Subject: WPNSTA Yorktown
27 January RI Review Meeting

WPNSTA YORKTOWN ROUND ONE RI REPORT

27 JANUARY 1993 MEETING

LANTDIV AND WPNSTA RI REPORT COMMENTS

Figure 1-3
 SOU-I (Sites 1, 3, 11, and 17)
 Indian Field Creek

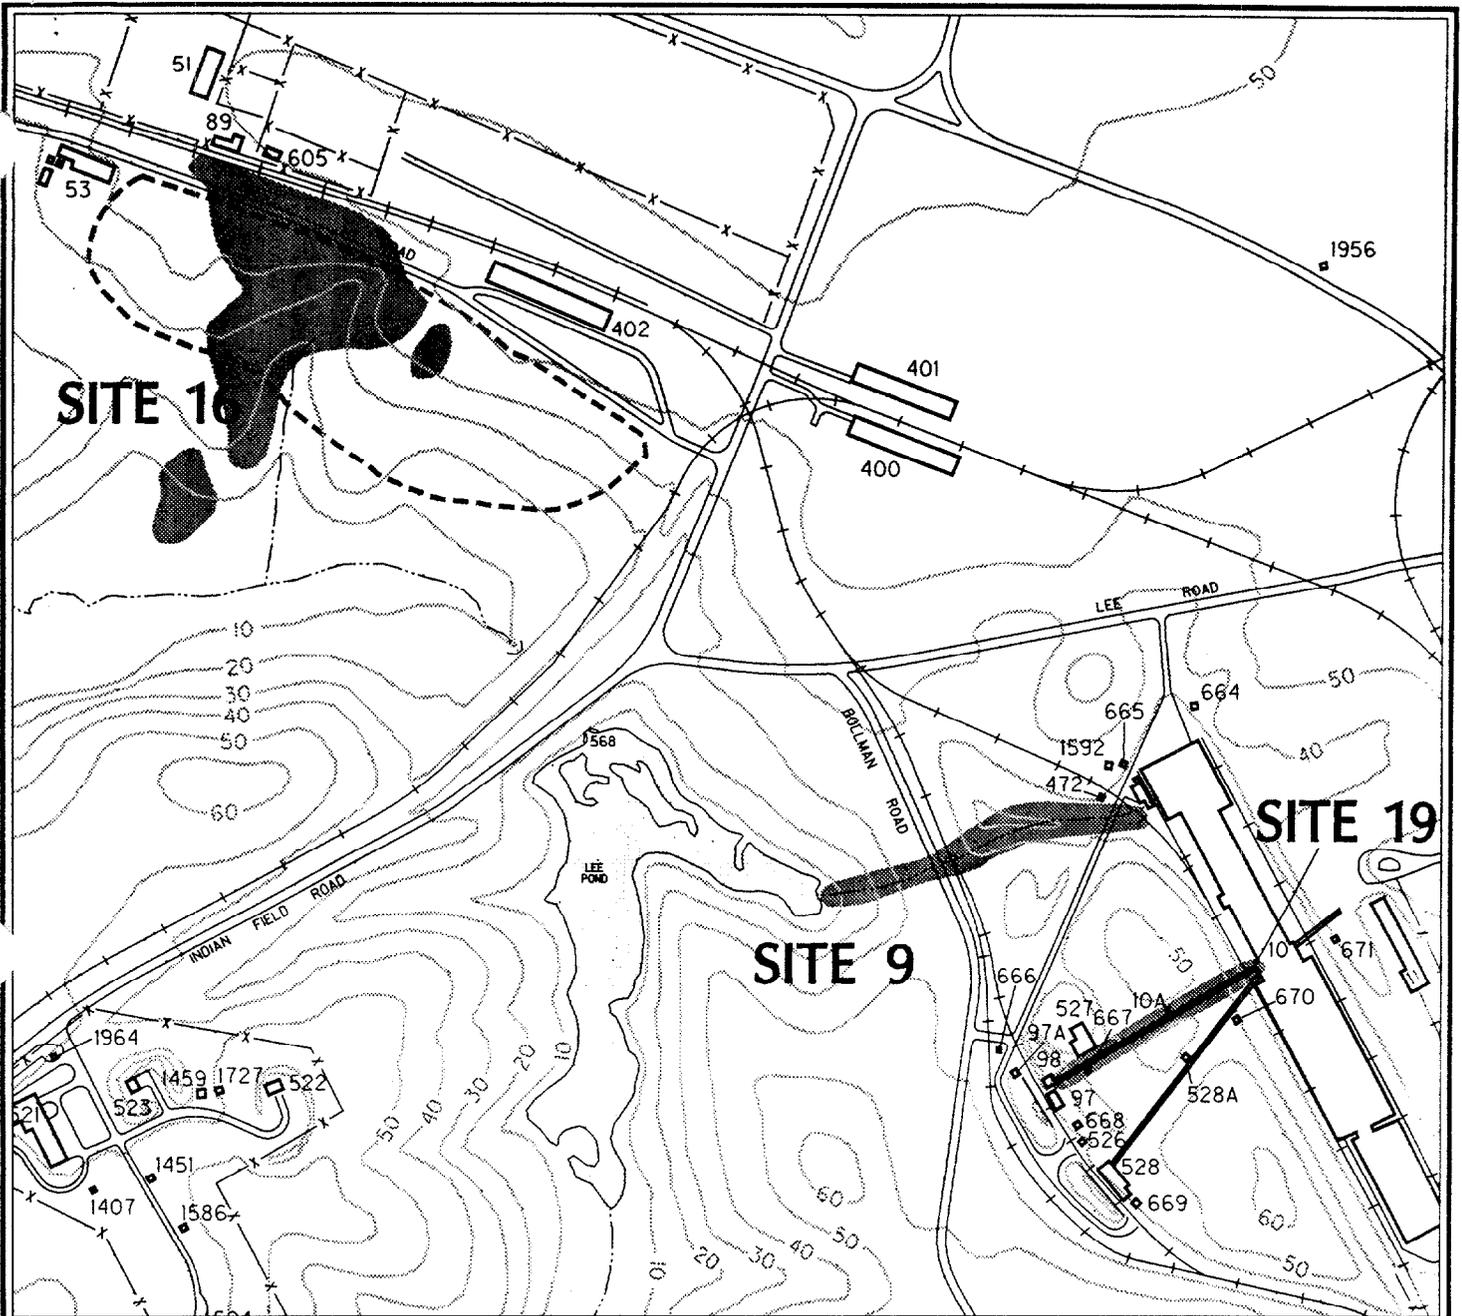
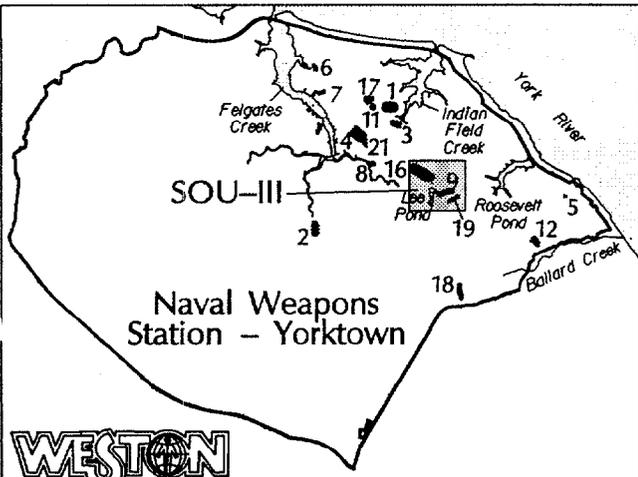
1. Geophysical Survey Report - There is no mention of this report in the Draft RI Report. How is the geophysical survey information being incorporated into the RI Report? Will site boundaries change as a result of that survey? Was the Government's money well spent by doing this geophysical survey?

- Discussions:
- Comment #1 WESTON will incorporate more extensively the results of the geophysical investigation into the RI report. Figures (attached) will be introduced in Section 4 outlining the source areas as delineated by geophysics. Those figures will provide the bases for the analytical data figures in Section 5. Also in Section 4, text will be added to summarize results of the geophysics at each site for which it was conducted. The entire report will be presented in Appendix A.
